New Model Introduction

New model GR-6100-527 is offered as a replacement for model GR-1350V-SDG. Models have common mounting and tooling and are dimensionally the same except as shown.

Gen 5 Model GR-6100-527 (7512175-1)

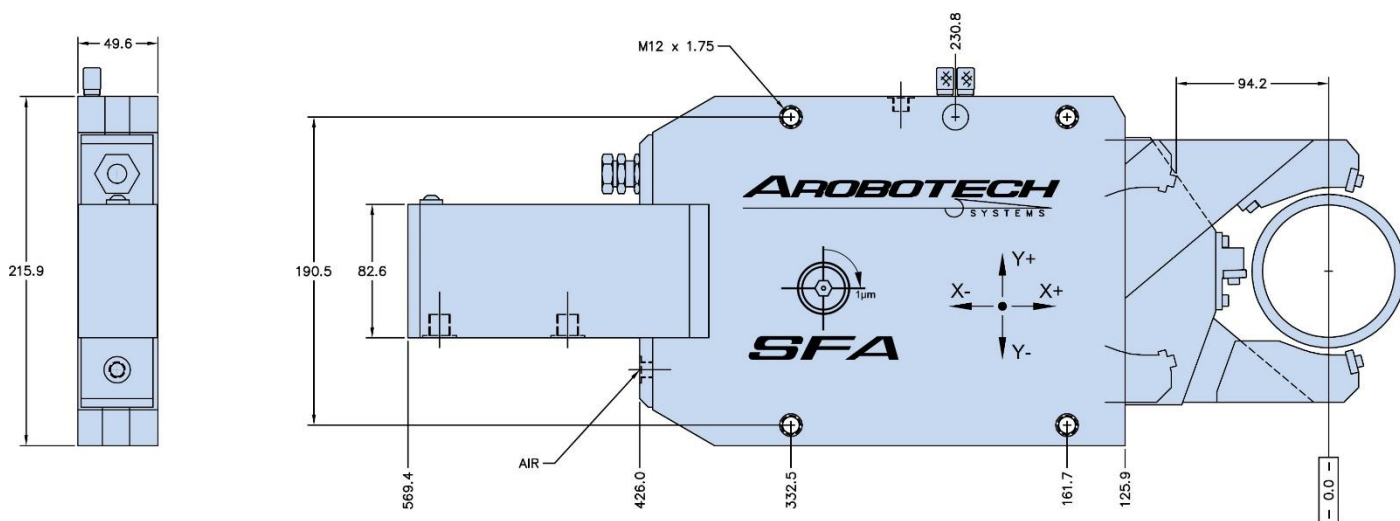
- * 95mm Maximum Diameter
- * 11.4 cm² Piston Area
- * 90° Turn = 0.001mm Adjustment (both axis)
- * +/- 0.200mm Total Adjustment (both axis)

- * 95mm Maximum Diameter
- * 11.4 cm² Piston Area
- * X-Axis = 3.1° Turn = 0.001mm Adjustment ▪ ±0.22mm Total Adjustment
- * Y-Axis = 10.4° Turn = 0.001mm Adjustment ▪ ±0.07mm Total Adjustment
